Re: Preliminary Plat for Lavitt Manor II—Two Lot Subdivision: 7525 N. Ironwood Drive

Based solely on the current Town of Paradise Valley Code and Storm Drainage Design Manual, the revised documents provided to this Commission by the Applicant for the proposed Lavitt Manor II subdivision have deficiencies requiring the Preliminary Plat be rejected:

5. PUBLIC HEARINGS 19-302 CONSIDERATION OF PRELIMINARY PLAT

SECTION

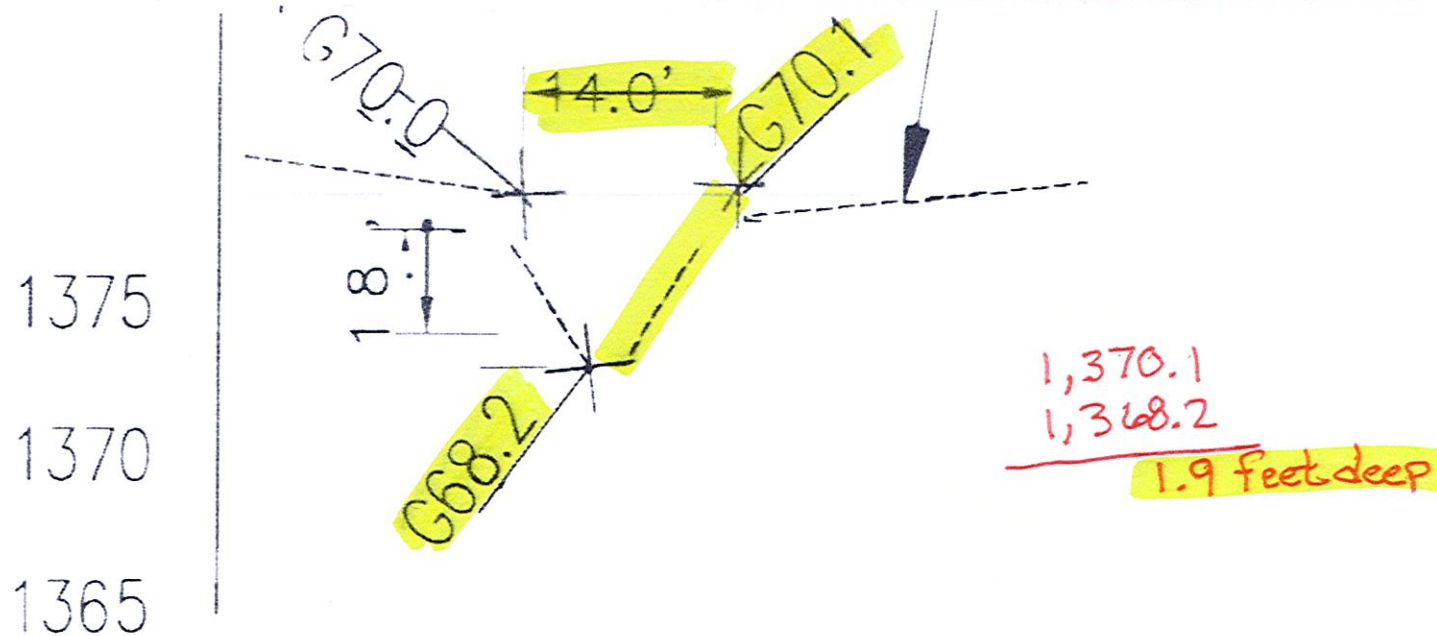
- Must consider both "historical banks" to determine depth;
- Nowhere does it say watercourse depth is taken from one bank, lowest bank, or existing grade of one bank.

- Paving Grading Drainage Exhibit showing:
 - Topography showing top of the bank of each side of the southern wash;
 - Separate line showing 5 foot landscape buffer on each side of the top of the bank;
 - Separate line showing proposed easement that reflects all points of the new easement are outside the 5 foot landscape buffer.
 - Revised Drainage Easement and Drainage Easement Agreement being provided to the Town of Paradise Valley reflecting southern Natural Wash inclusion.

- Revised Preliminary Plat reflecting all of the above.
- Recommend Preliminary Plat reflect the actual buildable square footage in northwest corner of Lot1.
